Town of Breckenridge
Planning Commission Agenda
Tuesday, May 19, 2009
Breckenridge Council Chambers
150 Ski Hill Road

PLANNING COMMISSION MEETING

Project Name/PC#: Allen Residence PC#2009018
Project Manager: Chris Kulick
Date of Report: May 6, 2009 For the May 19, 2009 Planning Commission Meeting
Applicant/Owner: Judy & Mike Allen
Agent: Mike Houx - BHH Partners
Proposed Use: Single-Family Residence
Address: 569 Gold Run Road
Legal Description: Lot 71, Highlands Park
Site Area: 35,513 sq. ft. 0.82 acres
Land Use District (2A/2R):

SUBJECT: Gondola Lots Master Plan
Class A Preliminary Hearing, PC# 2009010

RIDGE ST. DEVELOPMENTS: LOTS MCADOO

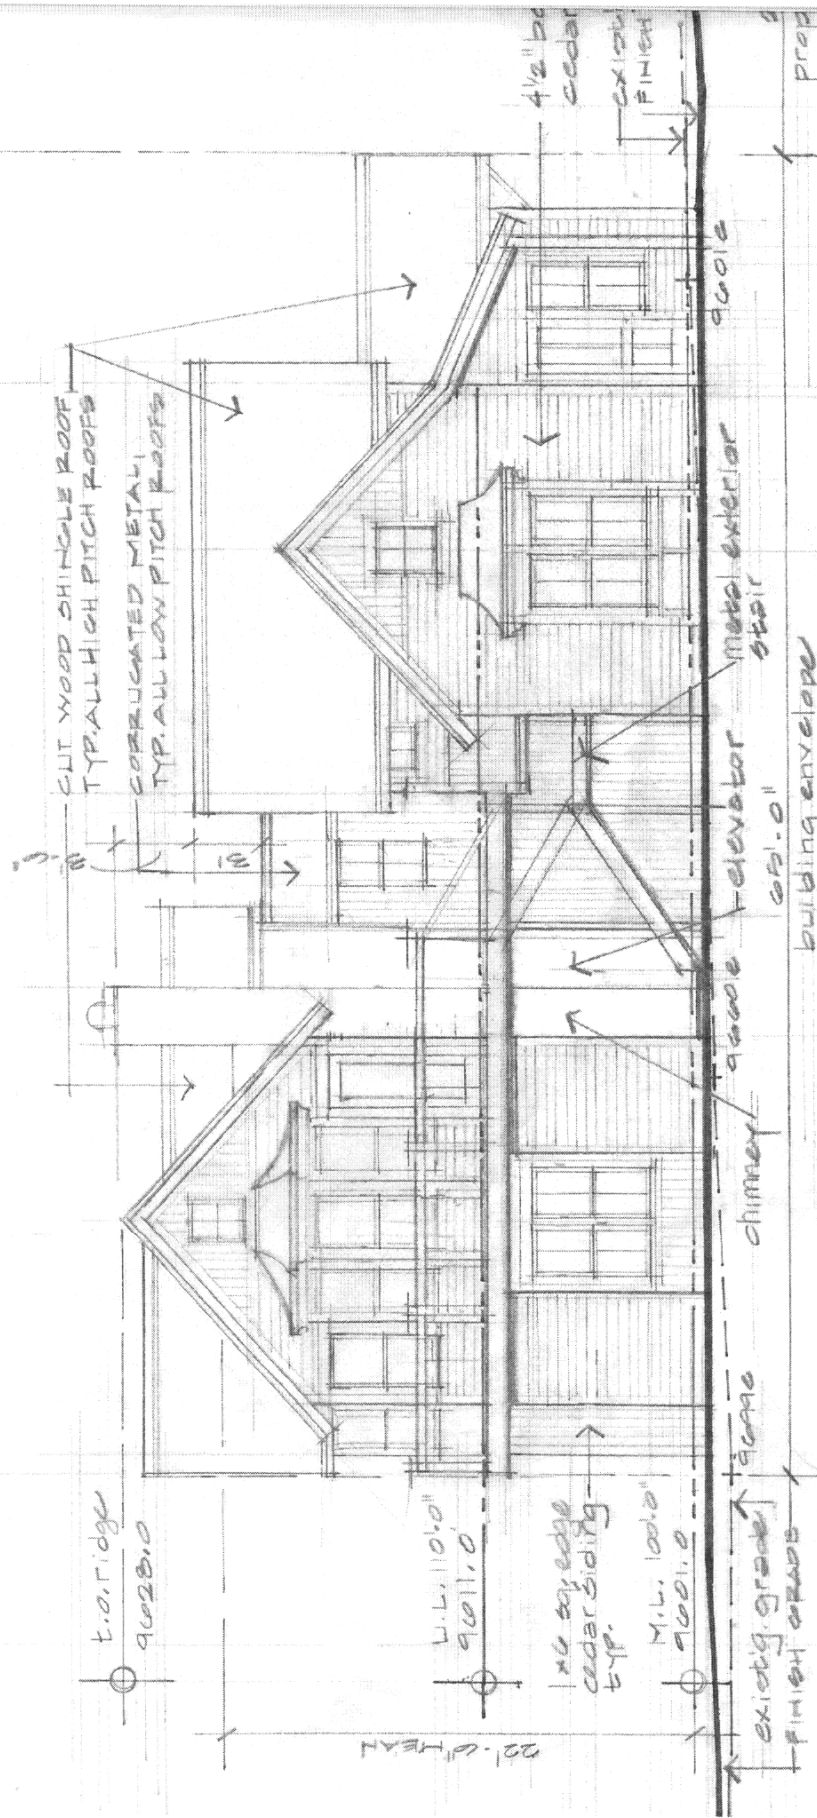
Staff does believe that Priority Policy 164 is being met. The front façade appears to be 20' in width. The secondary façade is 16' in width. Does the Planning Commission believe Priority Policy 164 is being met?

Refuse (15/R): All developments are encouraged to provide for the safe, functional and aesthetic management of refuse. Staff is concerned that there is not a grease trap at the dumpster enclosure. The proposed restaurant will need a grease trap.

Parking (18/A & 18/R): The Master Plan allocated four (4) parking spaces for Lot 5. However, a 3,365 sq. ft. restaurant will require twelve (12) parking spaces. ($3,365/1,000 = 3.365 \times 3.5 = 11.77$ parking spaces. For payments into the Parking Service Area, fees can include fractional spaces. Hence, the applicant will have to pay for the remaining 7.77 parking spaces in lieu of providing the required off-street parking at a rate of \$13,000.00 per spot, which equals \$101,010.00 dollars fee in lieu. (When the fee is paid in lieu of onsite parking, fractions of spaces are allowed to calculate the fee.)
